INTERNATIONAL SERVICE LETTER

1501/1530

TP-1780FN

Dec. 14, 1973

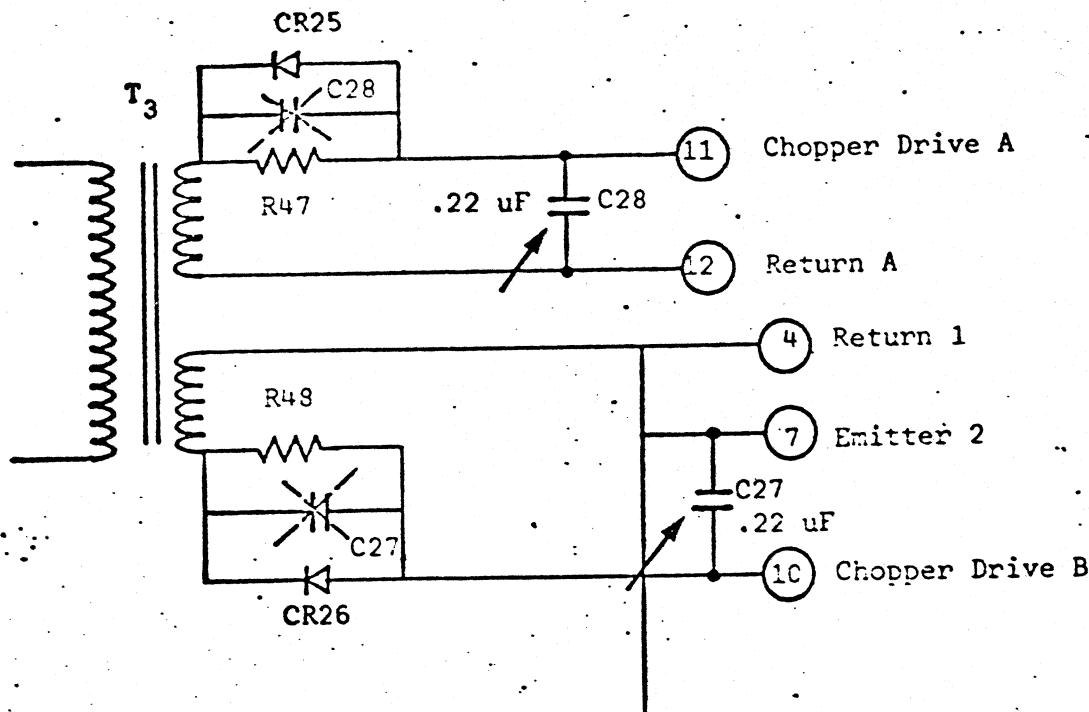
SUBJECT: 1501 Improvement Cogar P.S. Part No. 9009295-23.

REASON: To improve Power Supply Efficiency and reliability of choppers and chopper drivers, P.C. Board Assy: power supply primary has been changed.

CORRECTIVE PROCEDURE: 1) Remove capacitors C27 + C28.

- 2) Add .22 uF 50 V cap. from pin 11 to 12 on Primary Board
.22 uF 50 V cap. from pin 7 to 10 on Primary Board.
- 3) Update Schematics.

SUB-ASSEMBLY ProcessorSHT 1 OF 2DATE OF CHANGE RELEASE 9/12/73ECD NO. S-930

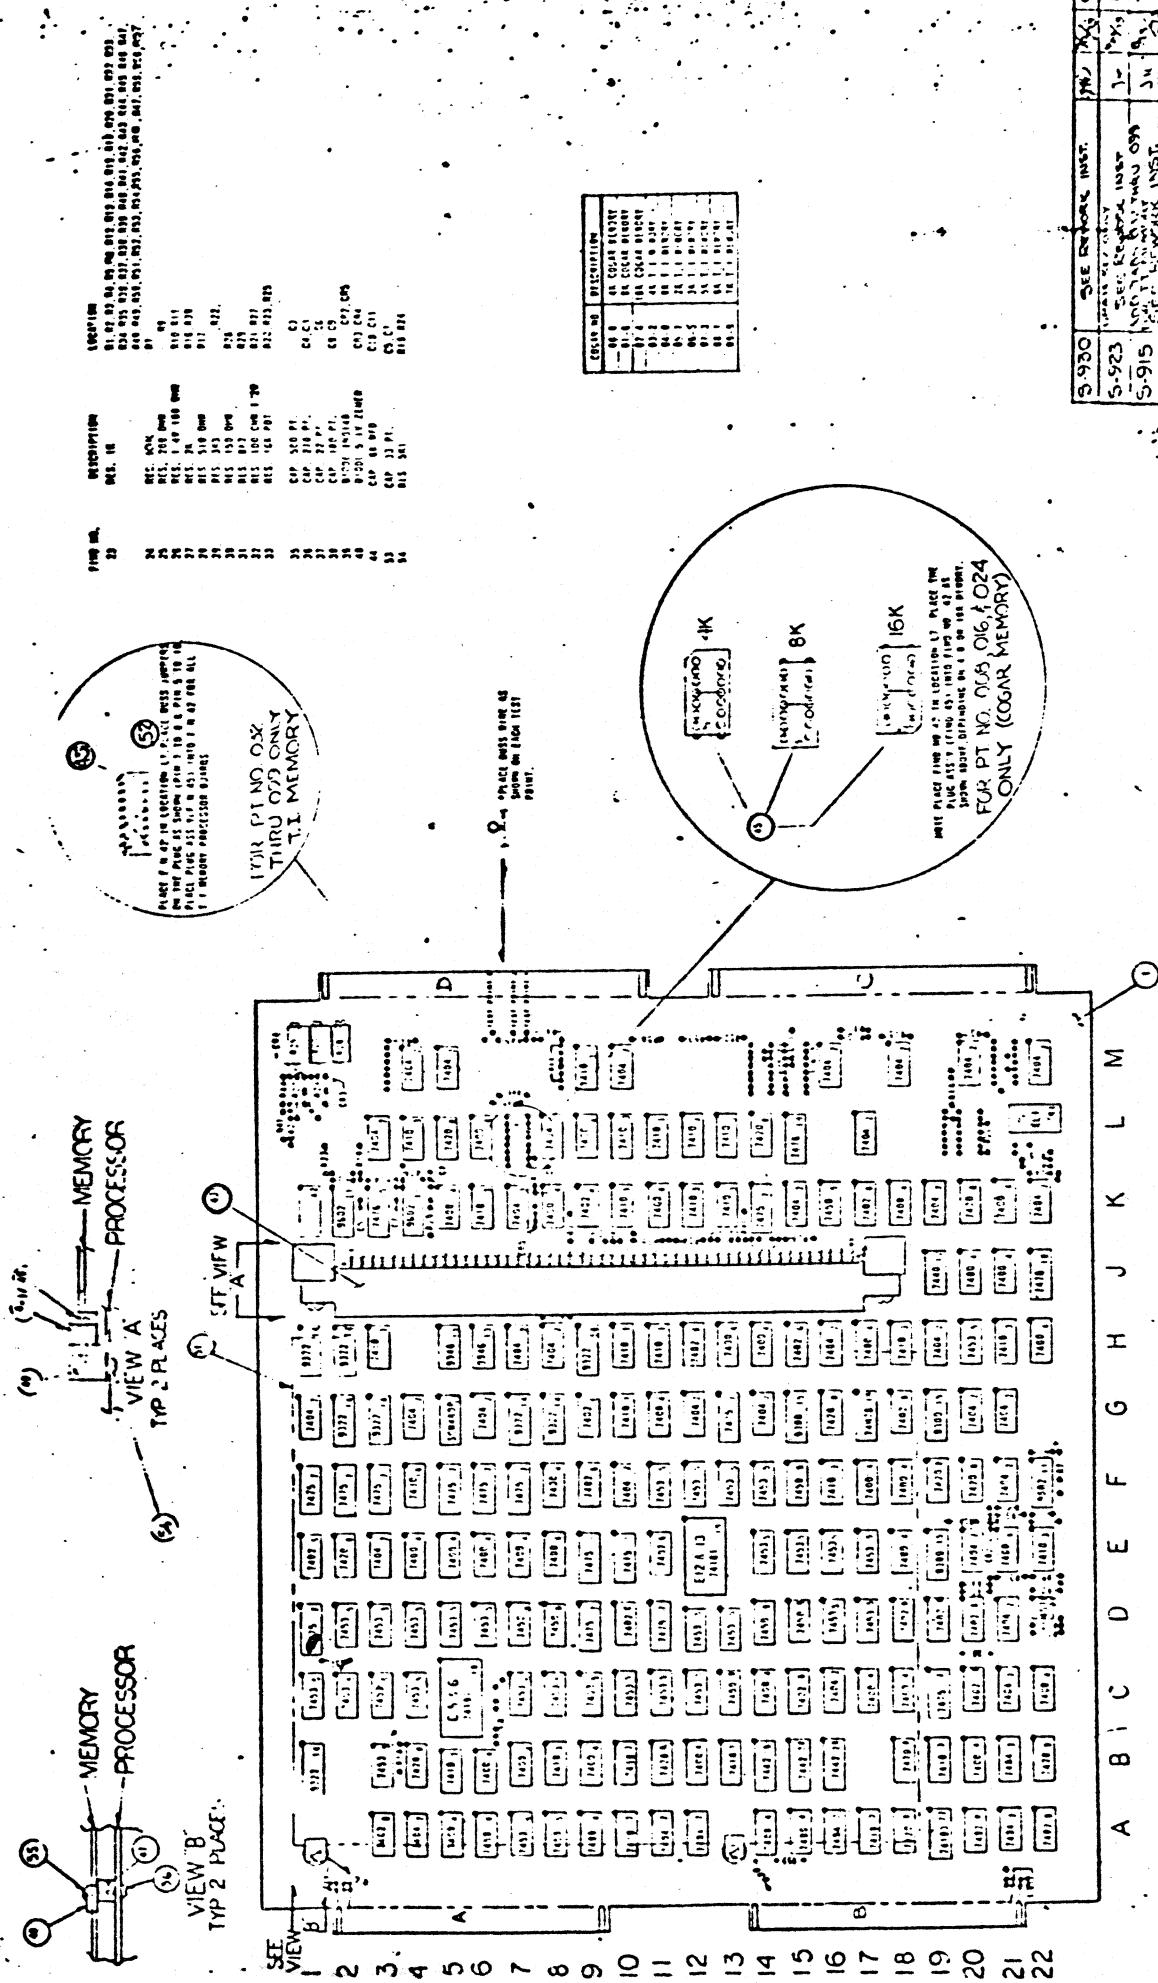
T.I. Memory Compatibility

- 1) Jumper G20-2 to Pin 2B12.
- 2) Cut Run to Pin 2 A78 to Component Side. (For Rev 2 Bare Bds-Cut Run from Pin 2 A78 to Feed Thru)
- 3) Jumper Pin 2 A78 to K17-5.
- 4) Jumper E20-1 to K17-6.
- 5) Jumper K17-4 to F14-13.
- 6) Cut the 2 Runs on the bottom layer at Mem. Conn. Pins 86 and 87. (Not required for Rev 2 Bare Bds.)
- 7) Jumper F19-13 to M9-9.
- 8) Jumper F19-12 to M9-10.
- 9) Jumper F19-9 to M9-11.
- 10) Jumper M9-8 to M22-11.
- 11) Jumper M22-10 to Mem. Conn. Pin 86.
- 12) Jumper F20-4 to K13-1.
- 13) Jumper F20-1 to K13-2.
- 14) Jumper F20-2 to K13-13.
- 15) Jumper K13-12 to M18-9.
- 16) Jumper M18-8 to Mem. Conn. Pin 87.
- 17) Lift E21-12.
- 18) Jumper E19-14 to L15-6.
- 19) Jumper L15-9 to L17-7.
- 20) Jumper E21-3 to L15-12 and L15-7.

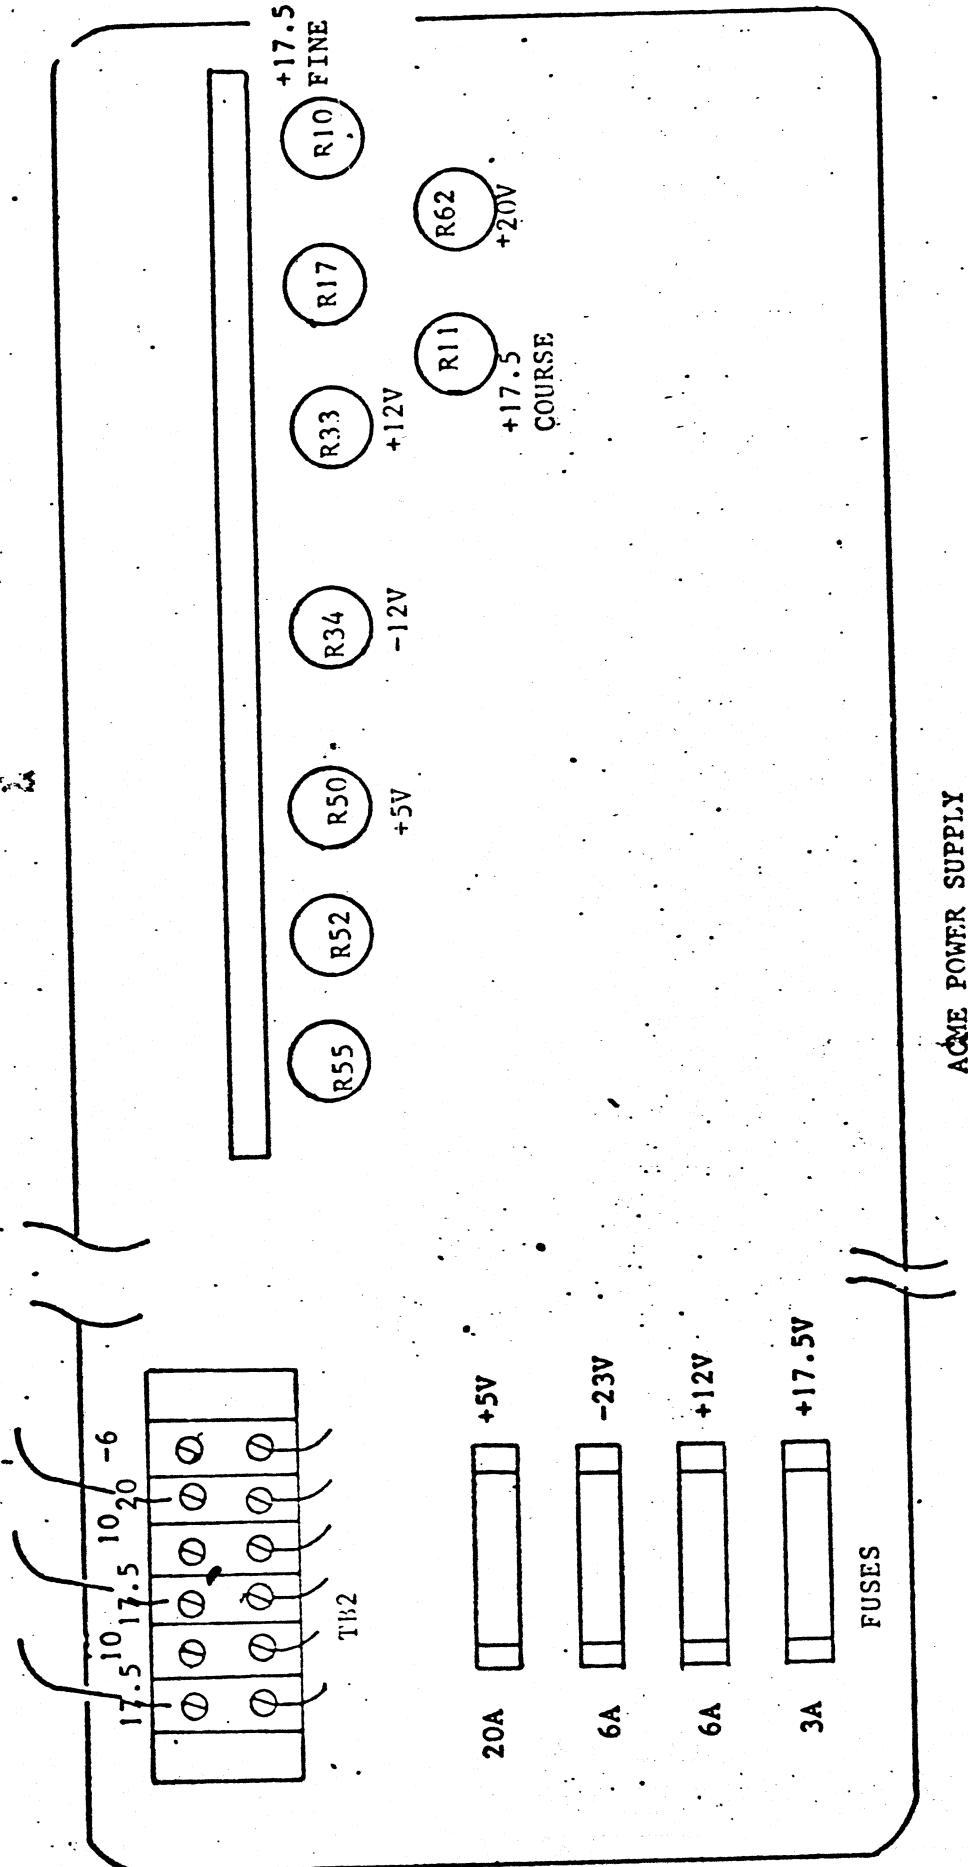
E. Set R10 (the +17.5V fine adjustment) in the midpoint of its swing. Adjust R11 (the +17.5V course adjustment) until the voltage is approximately +17.5v at the D.C. terminal block. Adjust R10 until the voltage is exactly +17.5.

F. Adjust R62 to obtain +20.0 volts at the terminal block. (T.B.)

G. Adjust R50 to obtain +5.1 volts at the T.B.

ACME POWER SUPPLY CONVERSION

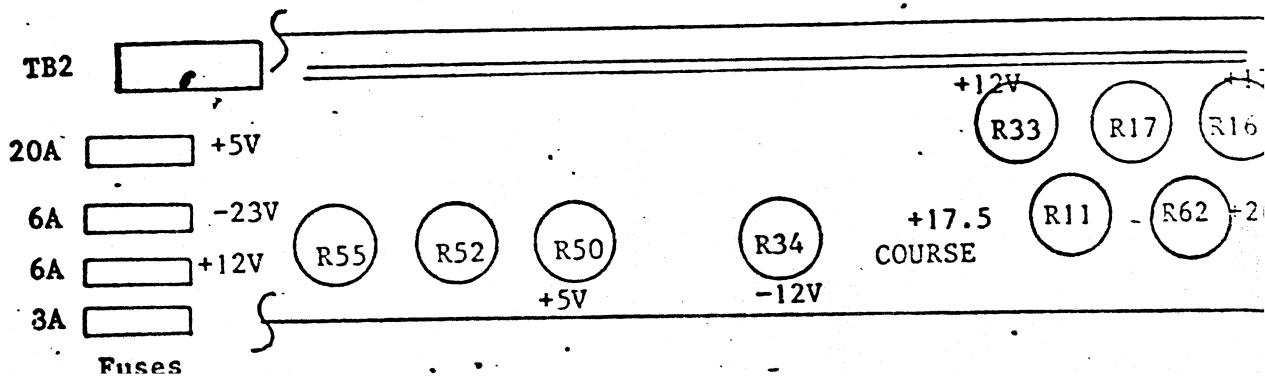
A. Replacing TI Memory with COGAR Memory

1. Move Power Supply Terminal Board No. 2 (TB2) leads from +17.5 to +10V (2 places) and from +20V to -6V positions. This is explained by moving the wires of the terminal board up one position. This is on the tape deck side of the power supply; TB2-1 to 2, TB2-3 to 4 and TB2-5 to 6.
2. Add jumper buss wires across R7, R13 and R14 on the P.C. card Assembly. These are located below the R33 adjustment pot.
3. Reset the +10 Volt output with pots R10 and R11. Set R10 to mid-range and adjust the output using R11. This is to allow the R10 pot to be used for the fine adjustment in the future.
4. Reset the +10 Volt over voltage with pot R17. The +10V over voltage should be set to 10.8 Volts.
5. Reset the -6 Volt output with pot R55.

1. Move TB2 leads from +10V to 17.5V (2 places) and from -6V to +20V positions. This is explained by moving TB2-2 to TB2-1, TB2-4 to TB2-3, and TB2-6 to TB2-5.
2. Remove jumpers across R7, R13, and R14 on the P.C. card assembly. These are located below the R33 adjustment pot.
3. Reset the +17.5V output with pots R10 and R11. Set R10 to mid-range and adjust the output using R11. This is to allow the R10 pot to be used for the fine adjustment in the future.
4. Reset the 17.5V over voltage with pot R17. The +17.5V over voltage should be set to 1.9 volts.
5. Reset the +20 volt output using pot R62.

DRAWING 29
WIRED MODULE

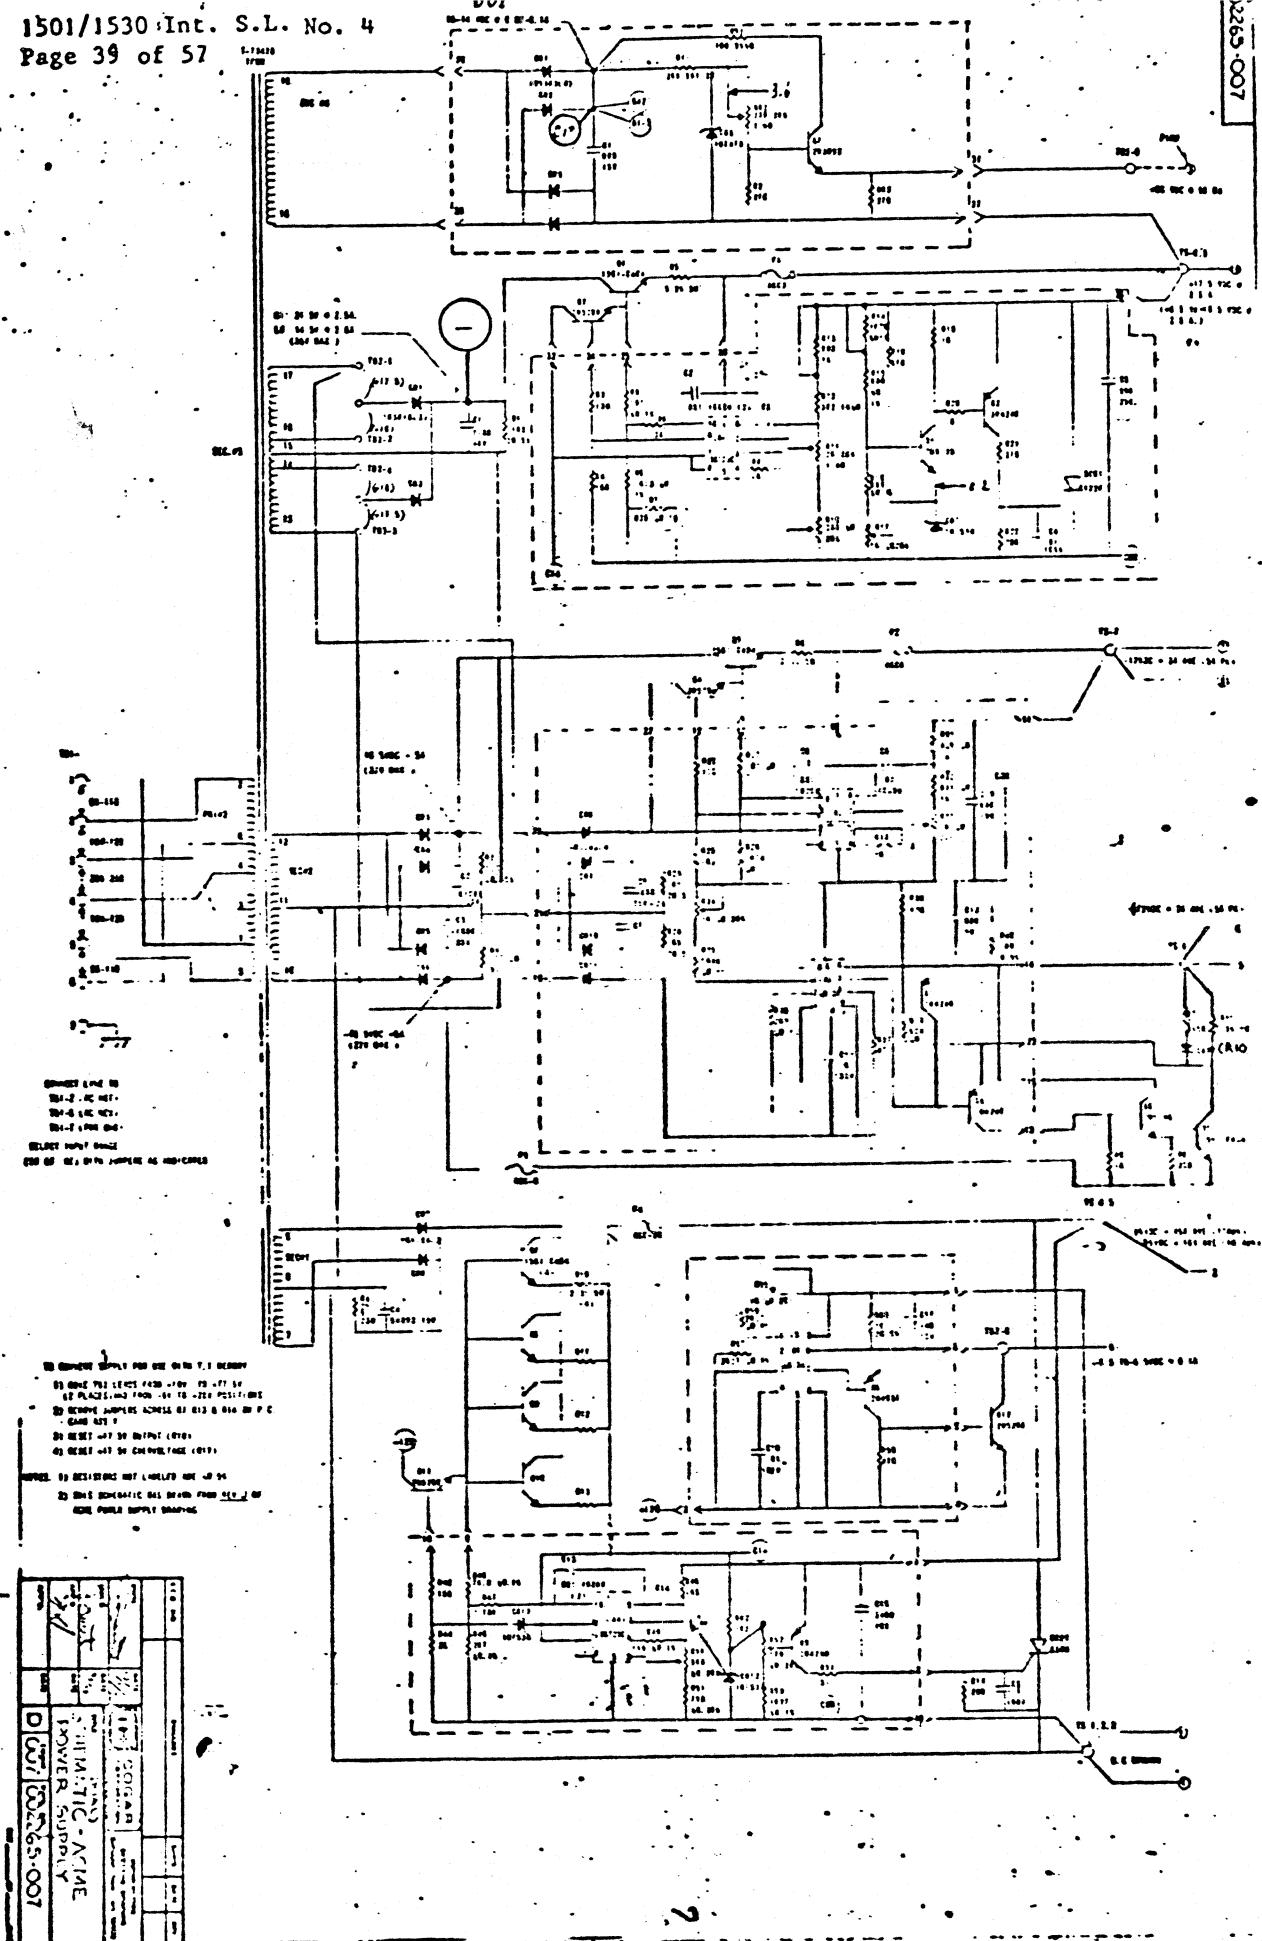
- G. Insert the T.I. memory with processor bd. and the Tape/Crt/Io bd into the system.
- H. Put a jumper wire on pins 1B55 to 2B12 of the wired module. See the attached illustration of the wired module.
